## Engine Ticking Sound On 1998-99 GM 5.7L VIN R Engines

The AERA Technical Committee offers the following information regarding an engine ticking sound on 1998-99 GM 5.7L VIN R engines. This noise may be described as similar to valve train noise or detonation and most noticeable when the engine is completely warmed up and driven under a load.

**Figure 1 - Baffle**

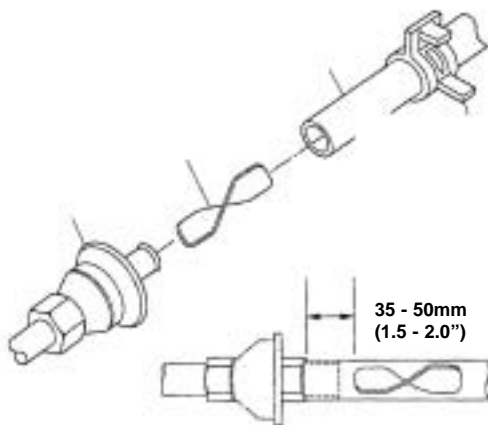
The noise may be due to an exhaust pressure wave that is migrating past the secondary A.I.R check valves into the hose plumbing. The pressure wave produces an objectionable noise similar to valve train noise or detonation.

To cure this problem, GM offers a baffle under Part #12562714 as shown in Figure 1. To successfully fix this problem, three of the baffles will be required. These locations are in Figure 2. These baffles are installed into the A.I.R hoses and should be 1.5" - 2.0" from the end of the hose.
